ACCESSION NBR: 8201260202 DOC. DATE: 82/01/11 NOTARIZED: NO DOCKET #.
 FACIL: 50-397. WPPSS Nuclear Project, Unit 2, Washington Public Power 05000397.
 AUTH. NAME: AUTHOR AFFILIATION
 BOUCHEY, G. D. Washington Public Power Supply System
 RECIP. NAME: RECIPIENT AFFILIATION
 SCHWENCER, A. Licensing Branch 2.

SUBJECT: Forwards responses to remaining Reactor Sys Branch Questions
 211.129, 211.031, 211.148 & 211.209. Revised FSAR pages re
 ODDYN code will be incorporated into Amend 23..

Subject: NUCLEAR PROJECT NO. 2
RESPONSES TO REACTOR SYSTEMS BRANCH QUESTIONS
AND ODYN ANALYSIS WNP-2 FSAR REWRITE

Results are presented in Figures 211.031-1 through 211.031-4 for a bounding calculation of this event. The standard Appendix K assumptions were used along with these conservative initial conditions:

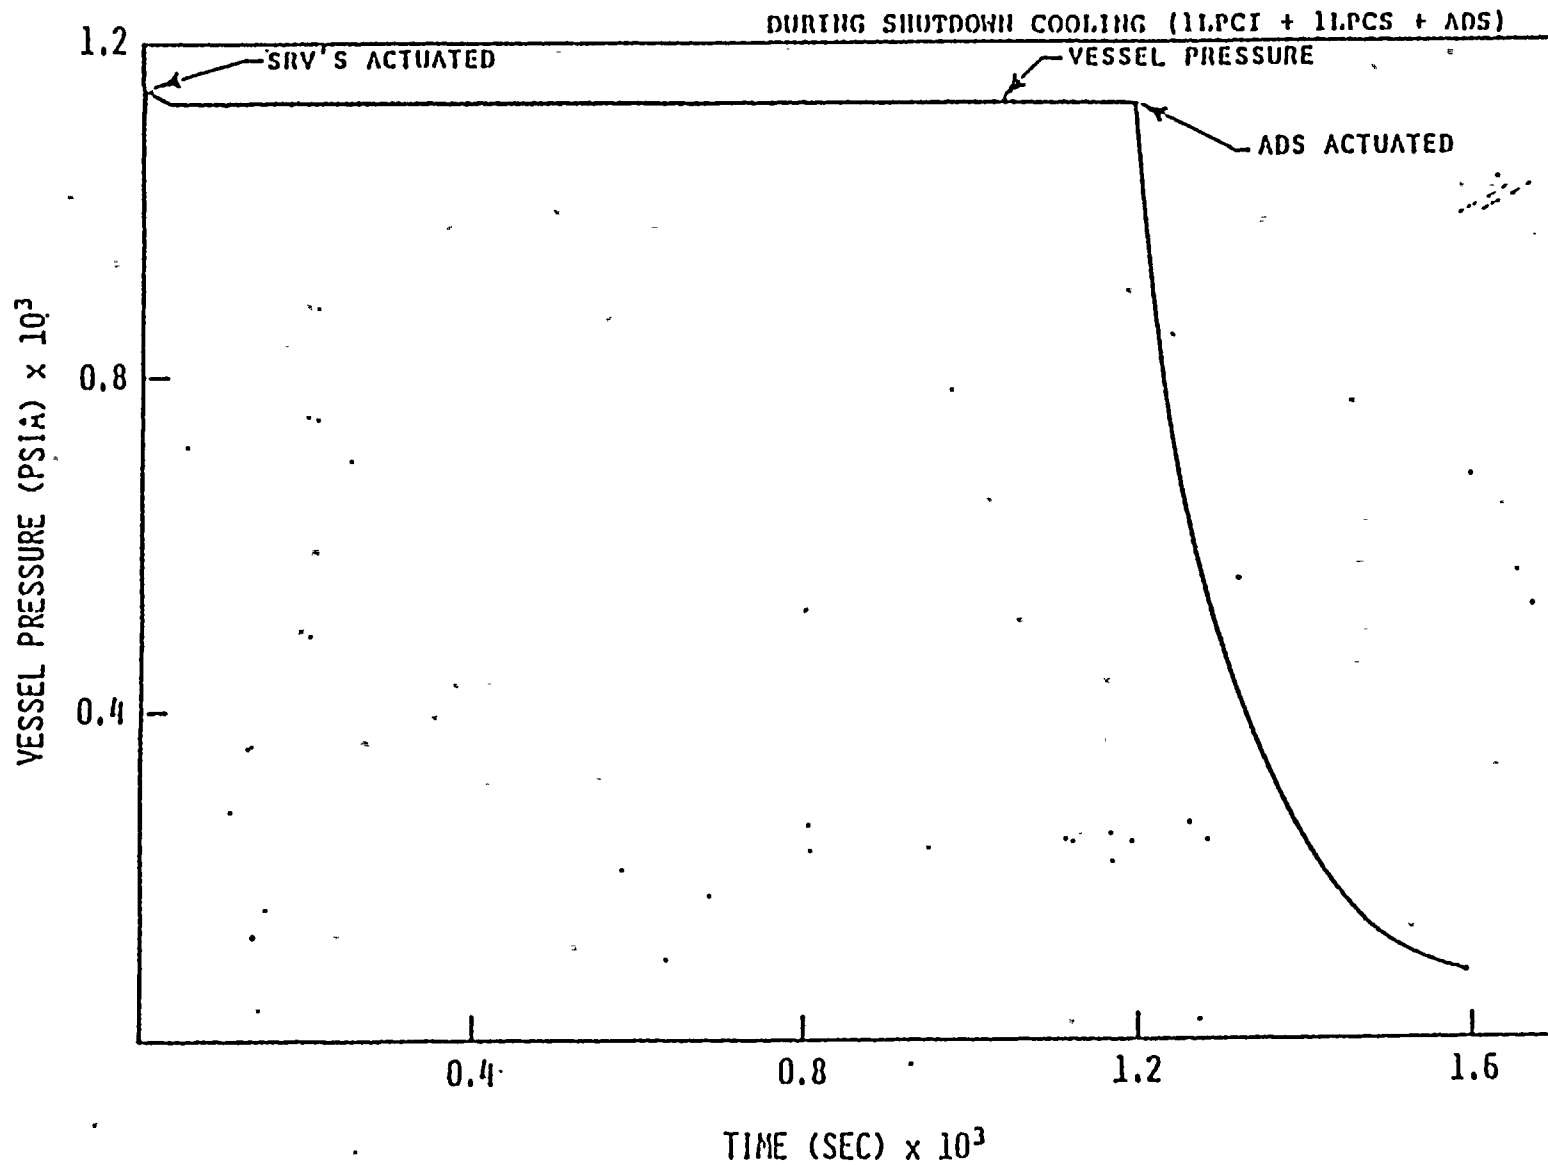
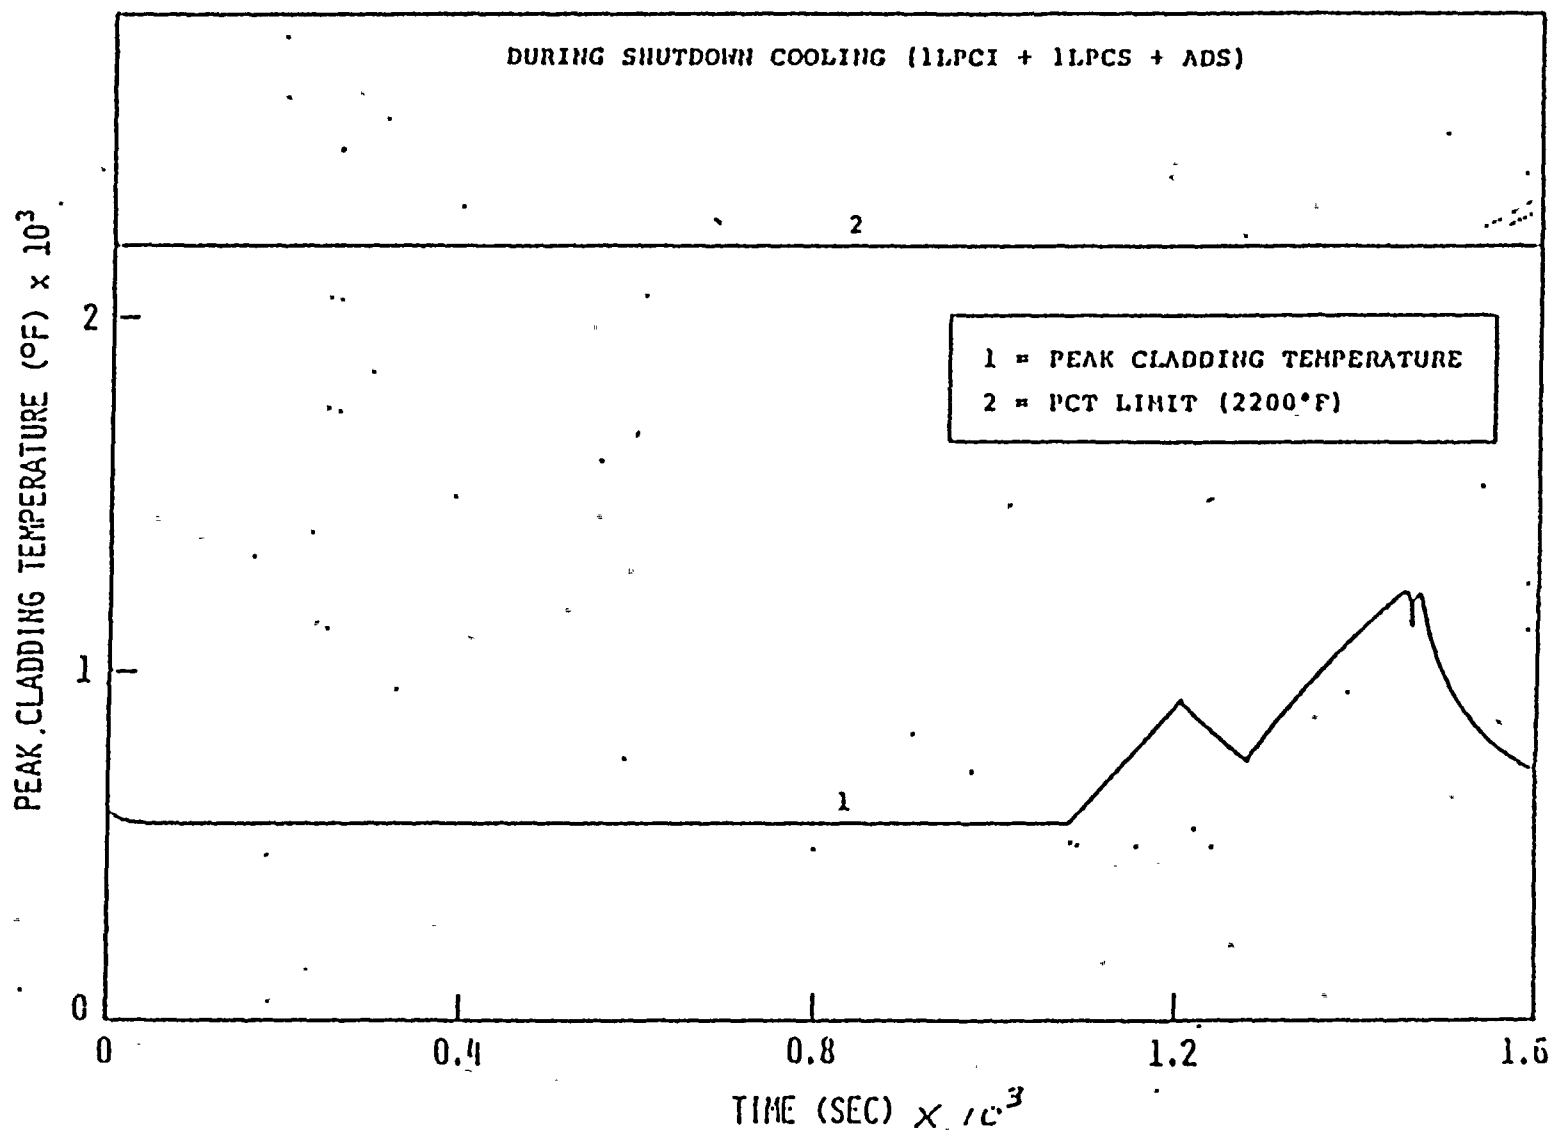
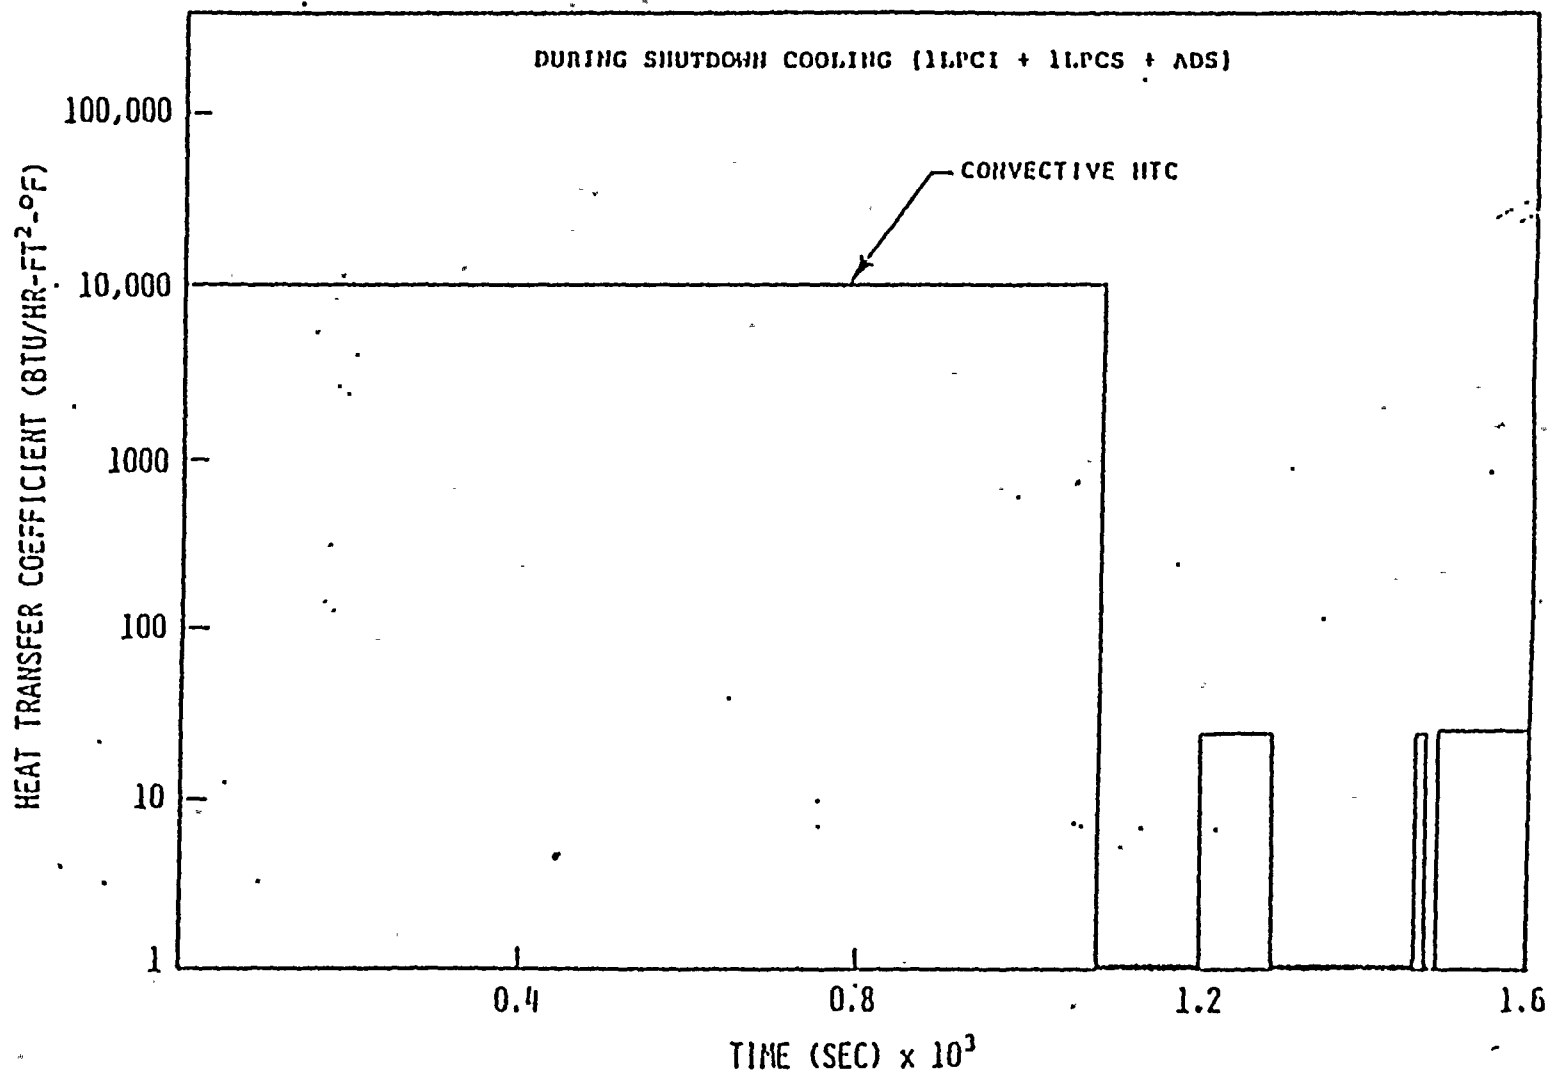
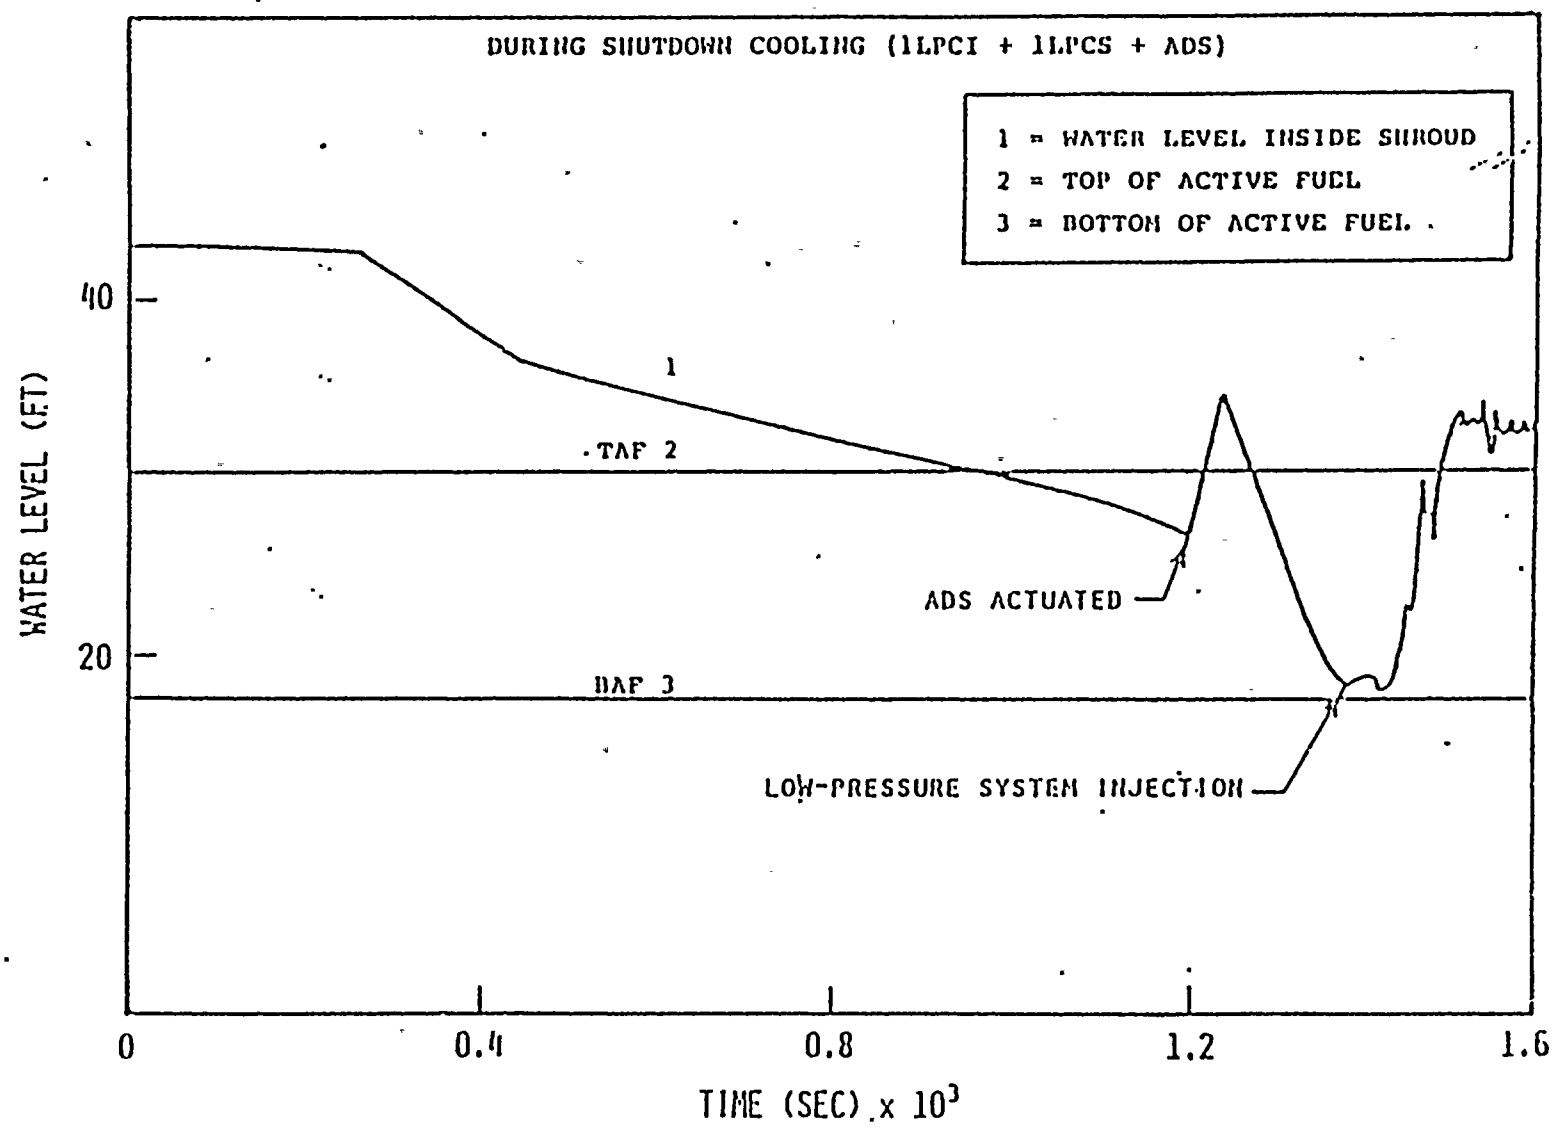
In Table 5.4-3 of the FSAR, you indicate that the RHR isolation valves MOF008 and MOF009 are closed upon generation of a signal indicating reactor low water level. It appears that you have mislabelled these valves in this table as "recirculation line suction" rather than as "RHR isolation". Indicate whether this valve isolation signal is based on the same signal as the RHR pump actuation in the low pressure coolant injection system (LPCI) mode (i.e., a water level which is 1.0 foot above the active core). If not, indicate the water level in the reactor pressure vessel at which the isolation signal is generated, thereby isolating the RHR suction valves. Show that cooling of the reactor core can be maintained assuming a pipe break outside the containment. Assuming a pipe break outside containment in the RHR system when the plant is in a shutdown cooling mode, provide the following additional information:

- a. Identify the systems available for maintaining core cooling.
- b. Indicate the maximum discharge rate resulting from the postulated break and the time interval available for recovery based on the discharge rate and its effect on core cooling.
- c. Identify the alarms available to alert the operator in the event of such a break and show that sufficient time is available for operator action to prevent damage to safety-related systems.
- d. Indicate what recovery procedures are available.
- e. Following a postulated break in a moderate energy line, the single failure criterion should be applied in the manner discussed in Section 3.6.1 of the Standard Review Plan (SRP) NUREG-75/087, and in Branch Technical Position APCSB 3-1, "Protection Against Postulated Piping Failures In Fluid Systems Outside Containment", November 24, 1975.

A special analysis for LaSalle was made of a hypothesized crack in the RHR suction line outside of primary containment during operation in the shutdown cooling mode. This analysis was performed with the standard GE LOCA models. For this event the realistic or actual system conditions are as follows.

No high pressure systems are available for water inventory restoration, i.e., no feedwater, no CRD flow, no HPCS, and no RCIC, but the reactor water level is at normal elevation at the start of this event. Vessel pressure is less than 150 psia and the MSIVs are closed at the start of this event. The decay heat is approximately 1% of rated power, i.e., approximately 4 hours have elapsed subsequent to reactor scram or shutdown.

For a conservative solution to this hypothetical event, the following sequence of events and conditions were assumed to exist or ensue from the hypothesized crack in the suction line:

- a. Crack occurs in the RHR line; water level decreases to reactor vessel level 3; then the RHR isolation commences and is completed 40 seconds later.
- b. System pressure rises as a result of the isolation to where the vessel pressure reaches the SRV setpoint thus causing them to open, blowdown, and reclose.
- c. Inventory depletion results from blowdown and from leakage out of the cracked line.
- d. The operator manually actuates ADS to reduce vessel pressure to where the low pressure ECCSs can replenish the water inventory.
- e. Water level is restored to within normal limits to protect the core from over temperature.

- a. The timing index was started at the RHR isolation (when Level 3 was attained) to neglect the time for the level to fall from normal water level to level 3 (about 2 minutes).
- b. An initial pressure of 1055 psia was assumed to neglect the pressure rise time from the 150 psia (pressure permissive for shutdown cooling) upon completion of RHR isolation to the 1055 pressure attainment. This results in increased mass loss during the 40 second isolation period due to greater driving pressure. It also decreases the time increment needed for pressure to attain the relief valve setpoint.

- c. The analysis assumes that scram occurs coincident with the start of the timing instead of 4 hours earlier. This assumption maximizes the peak clad temperature and steam production during the transient thus driving more fluid from the vessel and prolonging the blowdown phase.
- d. Only one LPCS and one LPCI loop were assumed to be available throughout the event. Operator action does not include possible diversion of the other two LPCI loops from the RHR mode.
- e. The crack area used in the analysis is defined consistently with the MEB 3-1 guidance for crack size. This crack area is consistent with FSAR postulates.

Results from this conservative analysis show that more than 20 minutes are available for the operator to depressurize the vessel. Once the system pressure is below the LPCI or LPCS shutoff head, the reactor water level is restored to normal limits very rapidly. The maximum clad temperature is much less than the arbitrary 2200°F limitation.

FIGURE
5.2-1

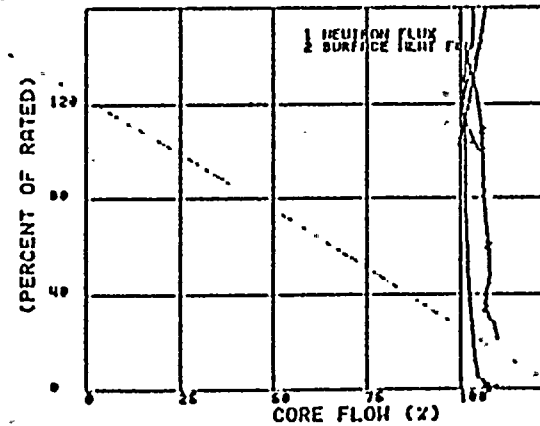
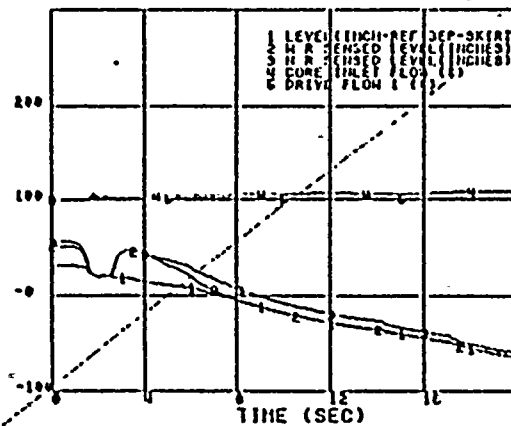
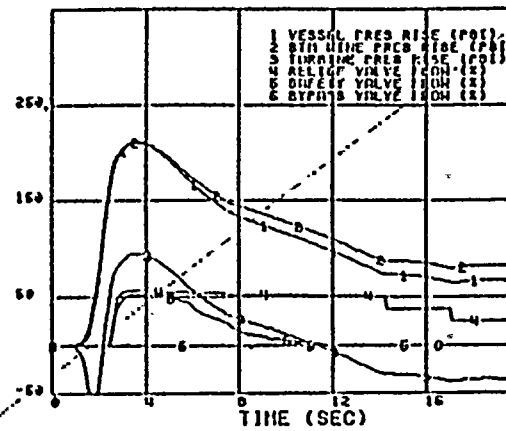
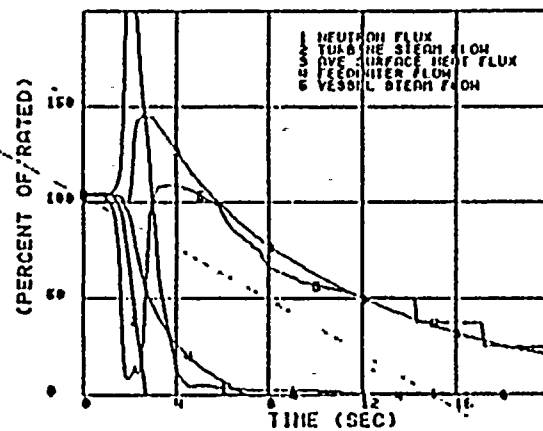
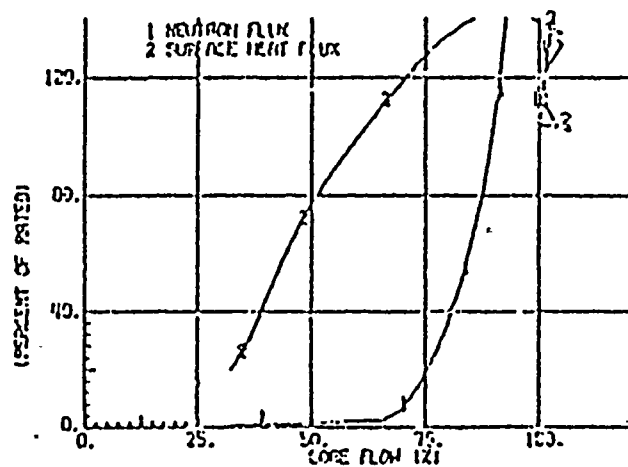
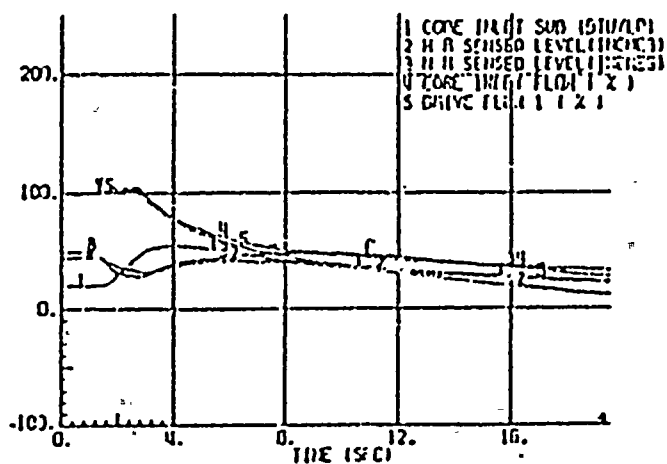
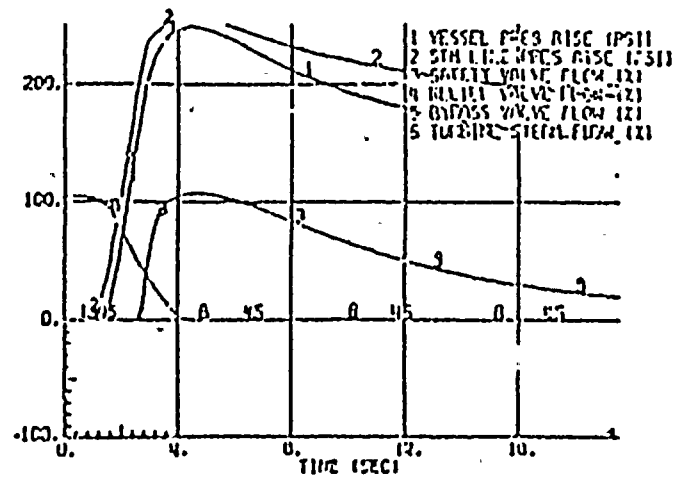
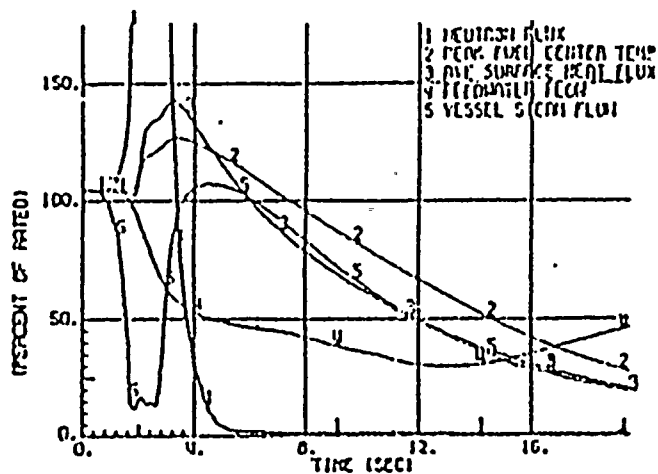
REPLACE WITH NEW FIGURE

and Figure 5.2-1a shows the result of ^{the} OBYN analysis.
